Firmware 2.06.3 bug list:

List of bugs/improvement requests

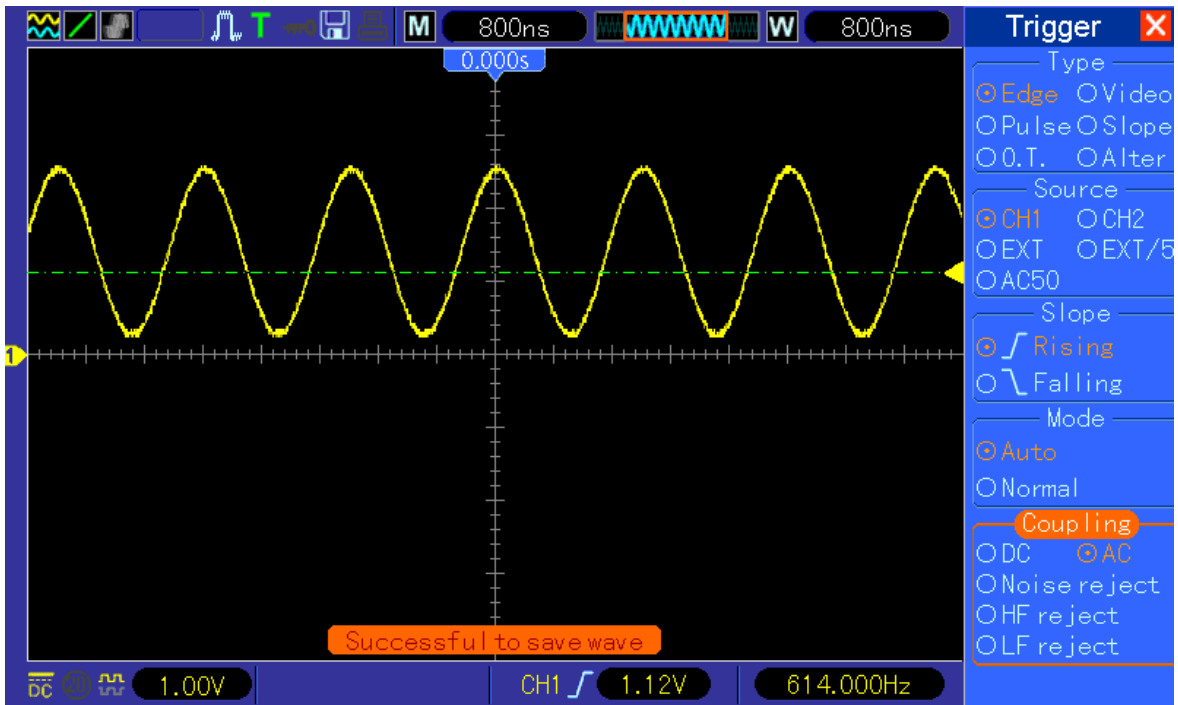
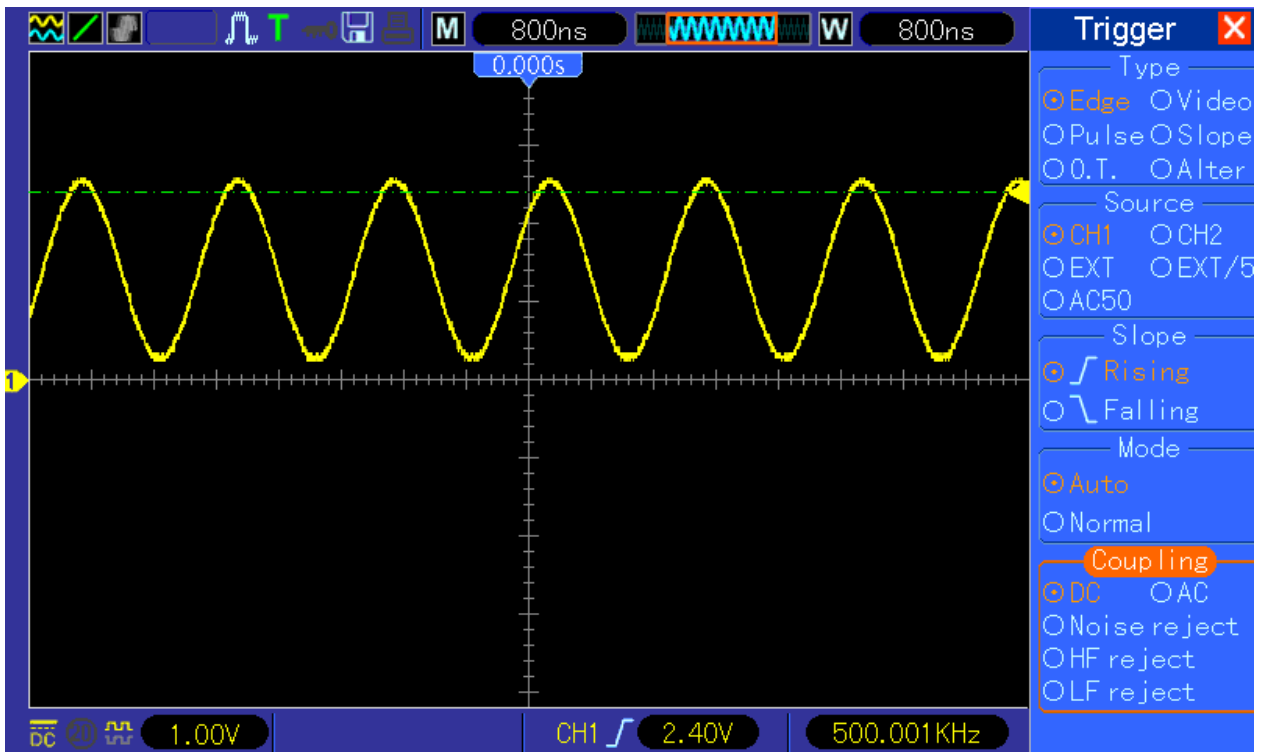
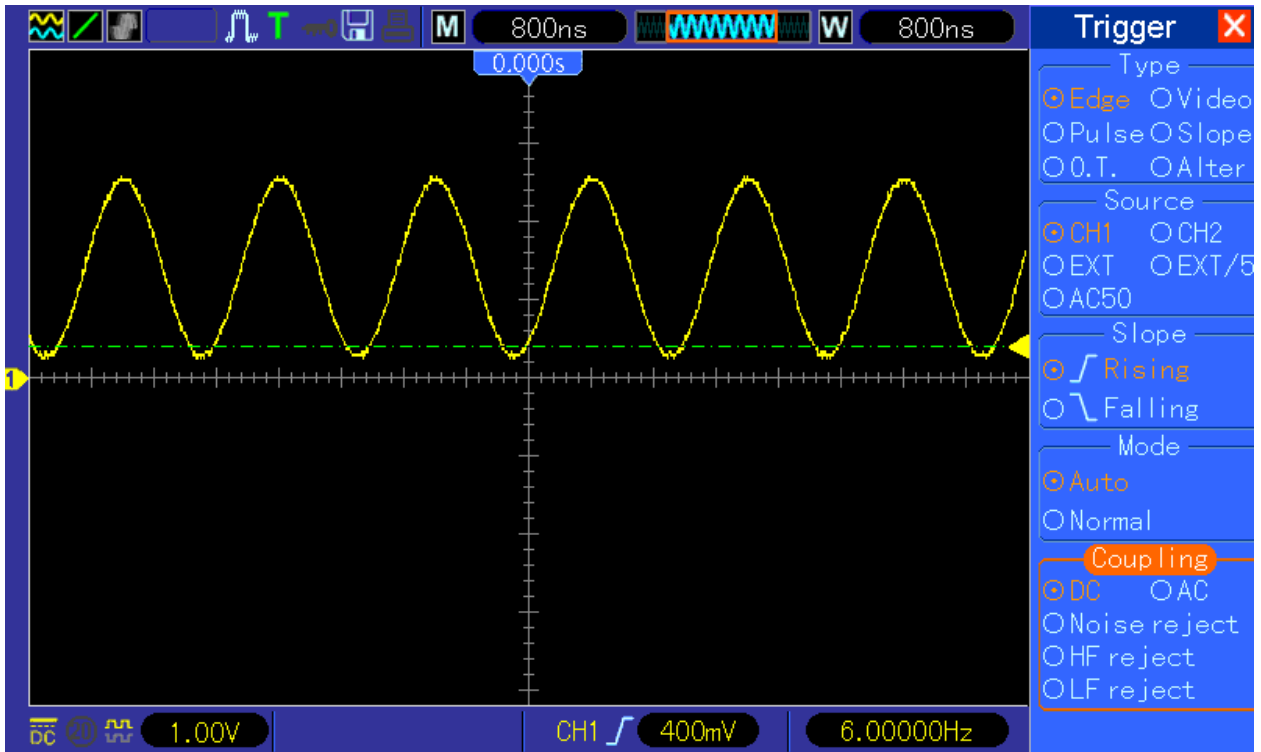
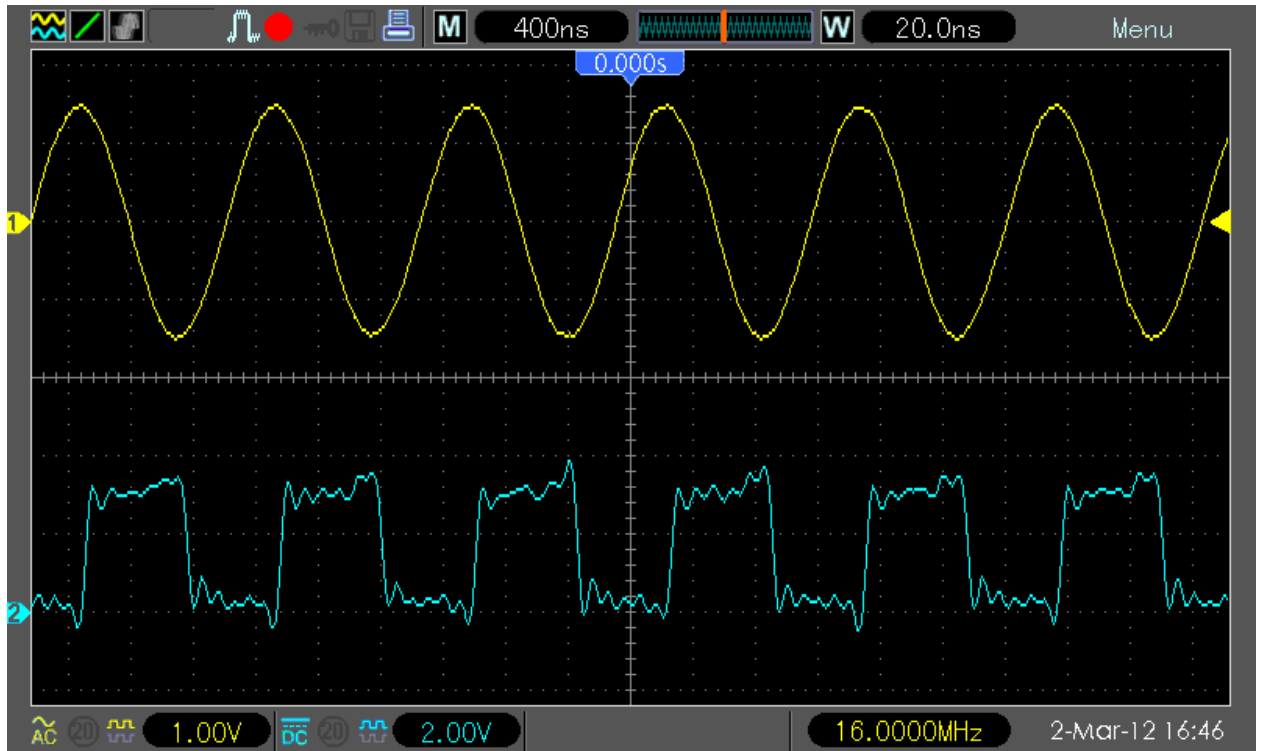
13. AC trigger indicator and line wrong. Set ch1, signal DC coupled, trigger AC coupled. The trigger lowest level below signal :

highest level only mid of signal

But both should look like when trigger coupled in DC mode:

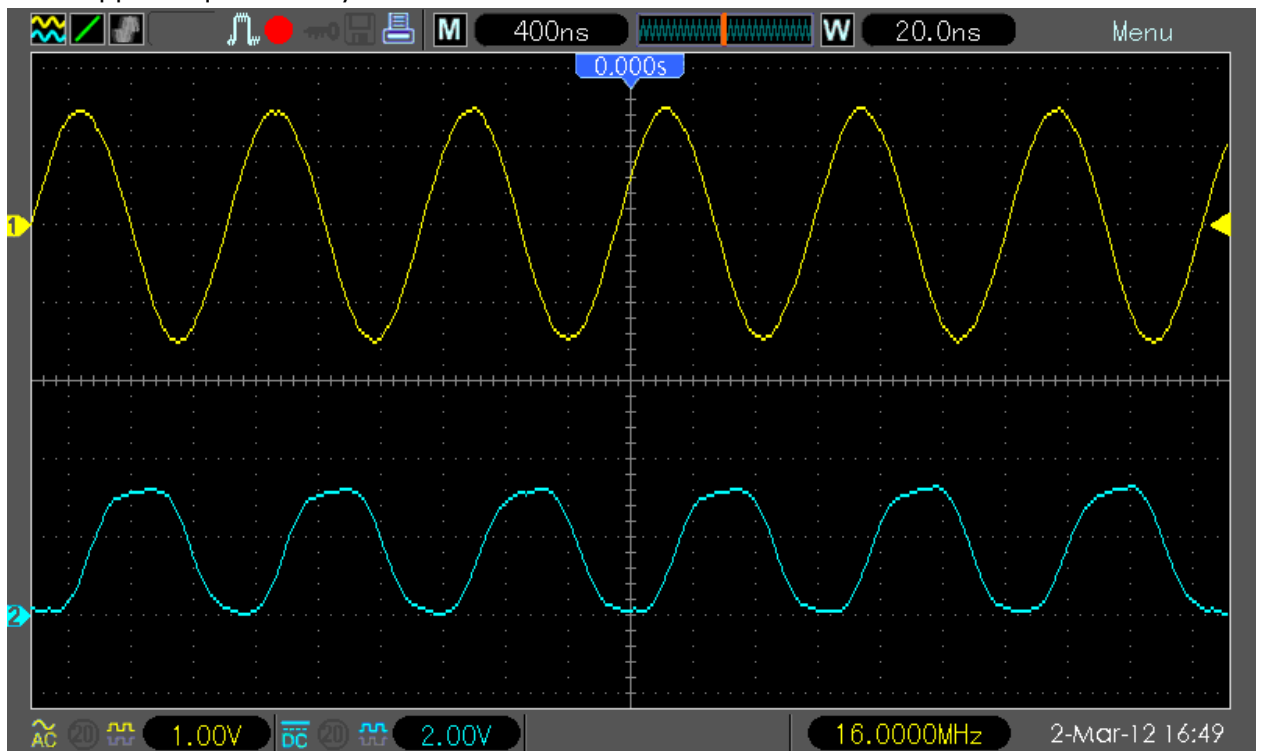
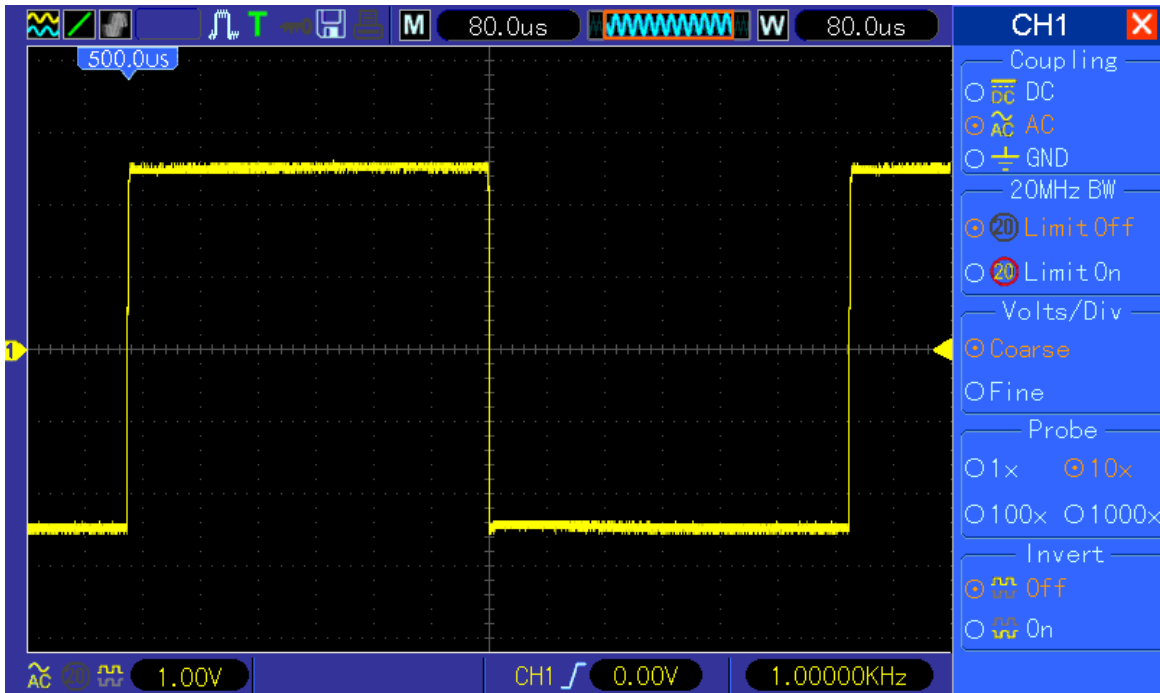
14. Dithering/interpolation filter of waveform too sharp. When enabling both channels (this also occurs in single channel mode and 1GSs, but test signal need to be higher to get same error) and applying for example 16MHz square wave the waveform is switching between proper square:

and crippled square every second:

14. For sure a stupid bug, but since you can see when the signal is “wobbling” you can quick change (when necessary) to single channel to observe the waveform with better resolution and without wobble.
15. Funny bug, but easy to omit since we know it (remember, with higher sample depth there is no issues)
16. This is already fixed, the /dsod (or /dso/app/dsod — this depends on fw/DSO model version) binary is working perfectly as watch dog monitoring potential profile issues.

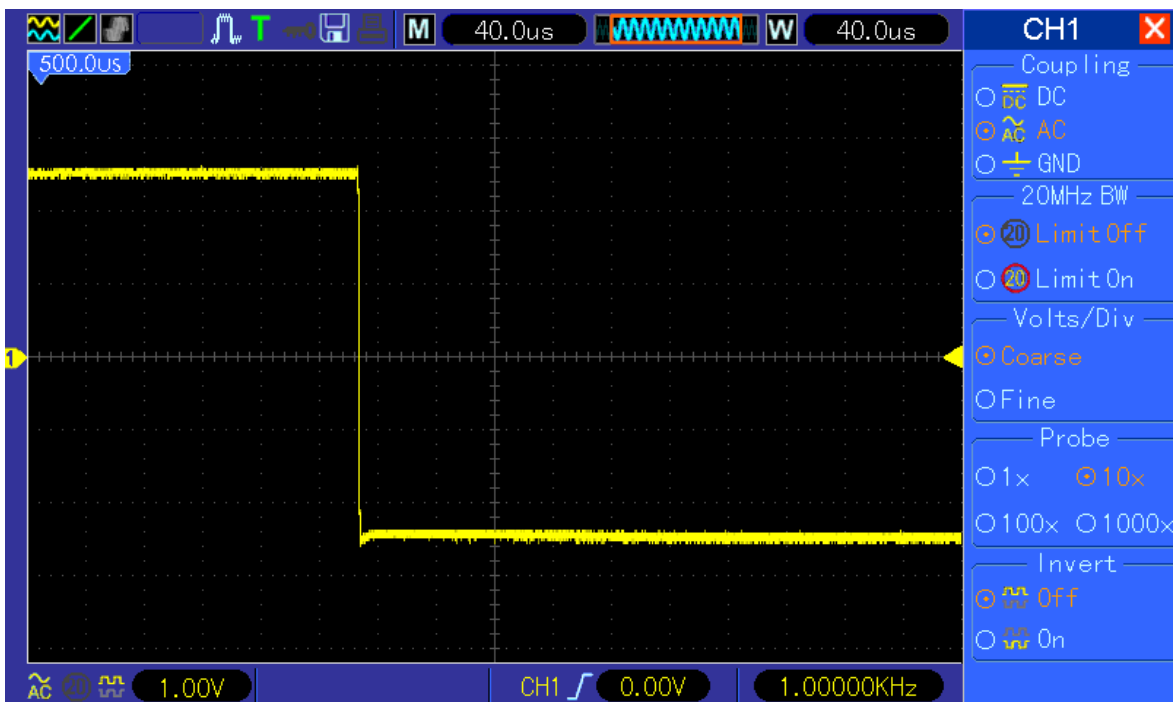
15. Display / Time base scaling strange behavior. When you apply e.g. 1kHz signal, set time base to 80us/DIV and move the waveform to 500us/DIV (bug only in 4/40k memory depth, 512k/1M/2M works fine):

When you now change time base to 40uS/DIV the falling edge (which should be still in the middle of the screen) has been moved to 454uS position (but it should stay on 500uS). The same happens of course with 20uS/DIV.

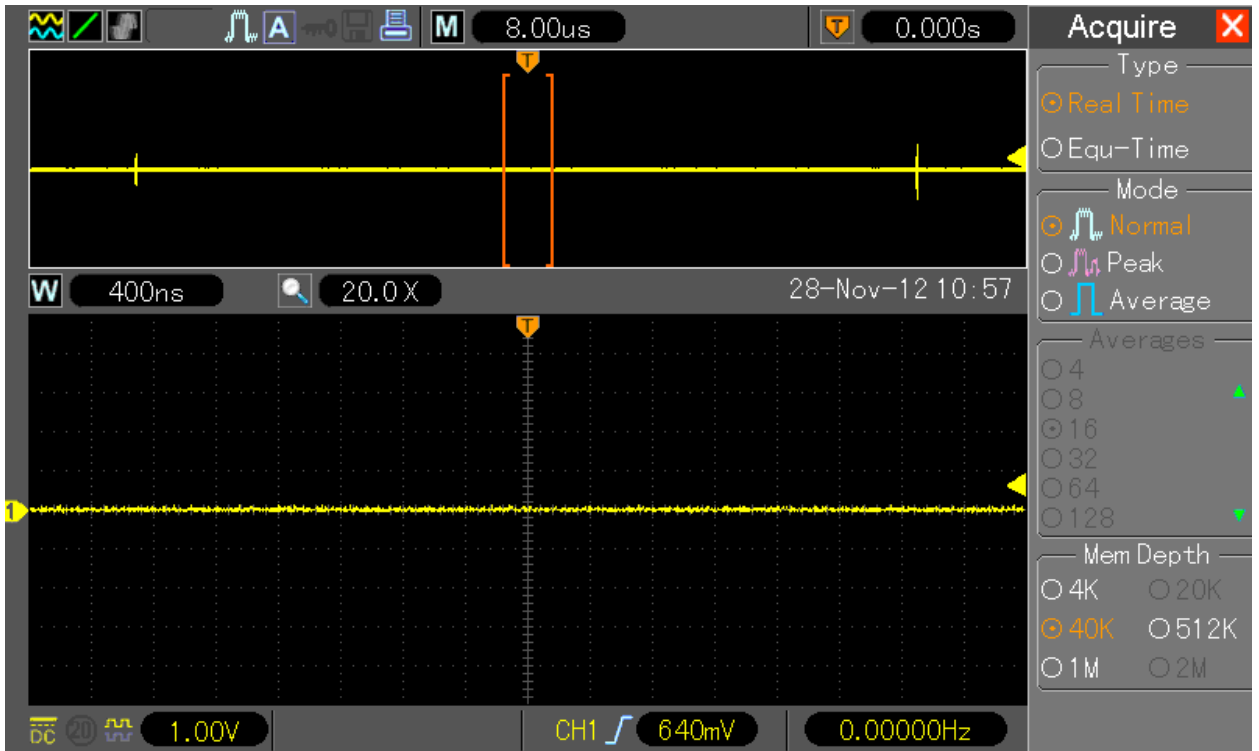
17. The new function “Wave” is no working properly in some models. There is missing the directory `/param/sav/wave_sav` on 2.6.13 kernel loaded DSOs.

Additionally there is typo in ARM source code,

once the file extension is `.hsw` and another time it is `.hws` – this is preventing the save/reload from USB to work properly and even sometimes crashing DSO.

From the file format I assume `.hws` is the proper file extension name

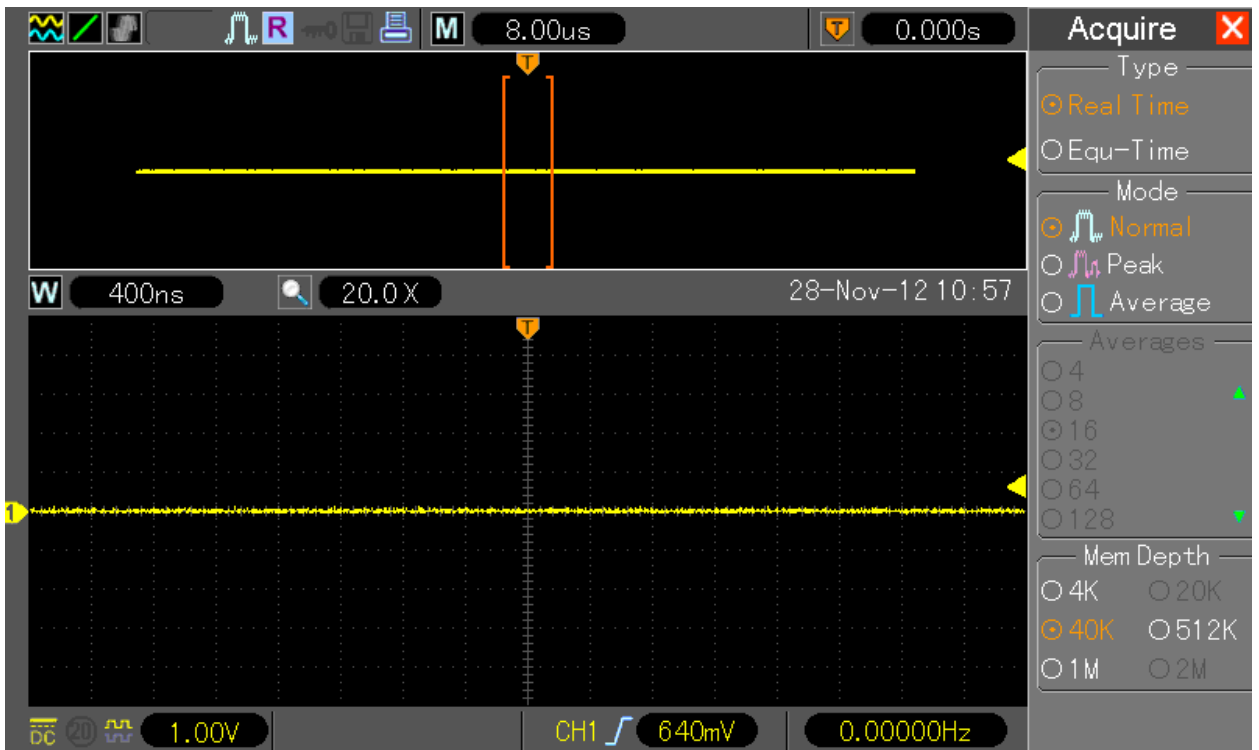
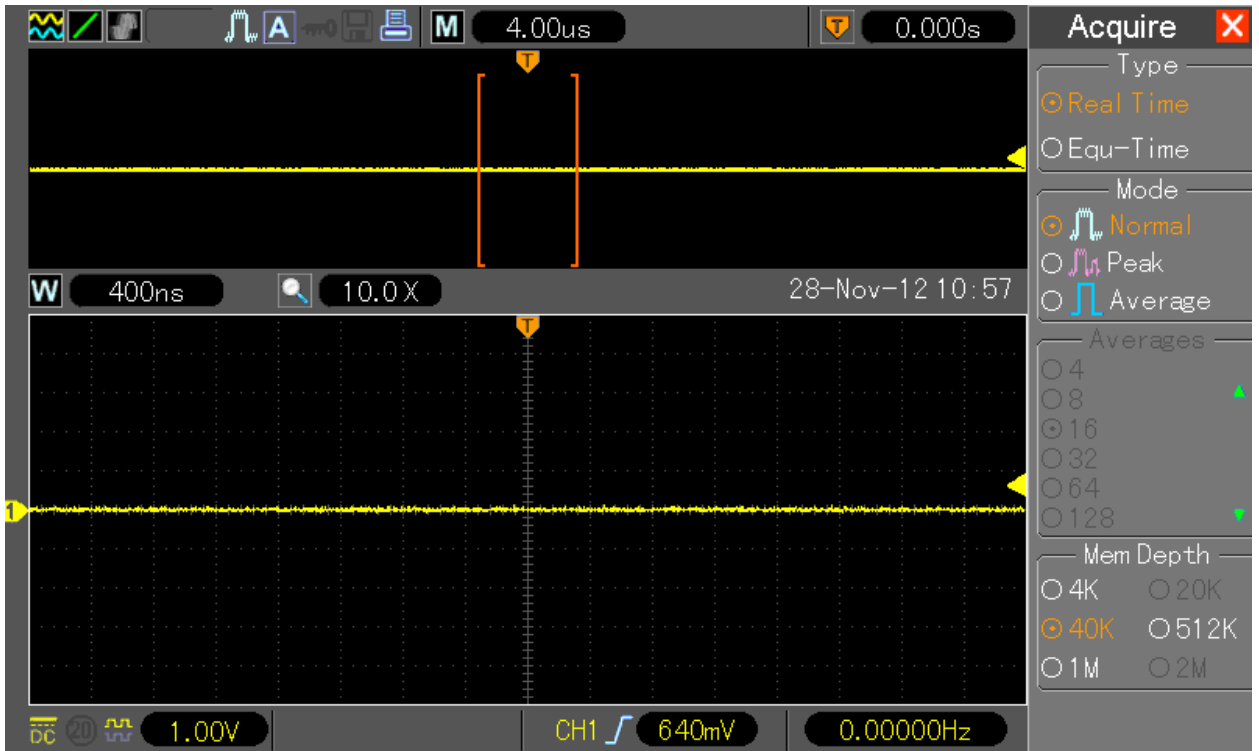
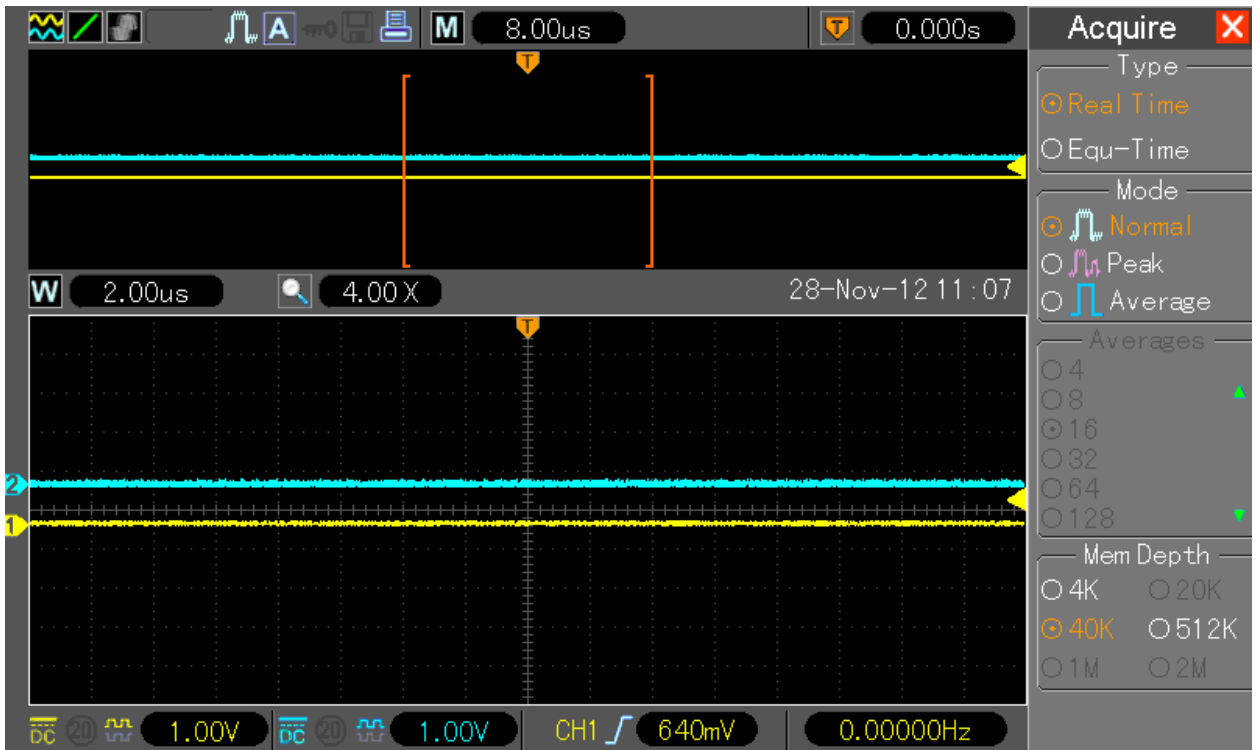
- 26. Main TB not always updating right after dual window enabled. No stability issue at all, scale changing immediately after any control changed. For an interim fw something we can accept as “minor bug”
- 27. While switching from single into dual window mode the main timebase is changing with a wrong factor, e.g. from 200ns/DIV in single into 400ns/DIV in dual window mode. Similar issue in 40k/512k and 1M – in dual window the MTB is twice that high as before in single window mode. Due incorrect timebase the display buffer is showing artifacts on both right and left side of the waveform (end of buffer). Example: CH1 enabled, 40k memory, single window and windows timebase smaller than main timebase, here 400ns/DIV (Main TB is 4us/DIV for 40k)

Now when switching to dual window the Main TB is changing to wrong value (here from 4us/DIV to 8us/DIV – actually it will be always doubled in length) and artifacts from “ned of buffer” right and left in top window are shown:

When the Acquisition could be stopped and restarted or Timebase changed one position forth and back (while Main window is focused) the Main TB and displayed data will be fixed to proper length; no artifacts shown anymore:

With 2 channels enabled this bug **DOES NOT EXIST**, this is because the doubled Main TB value is exactly what it should be for dual channel view:

26. Just ignore it for now; it is interim fw version – for testing only.
27. Switch once focus from minor (bottom window) to major (top window) window by pushing timebase knob down, turn then timebase one position fort and back to get rid of waveform artifacts on left and right side of the waveform.
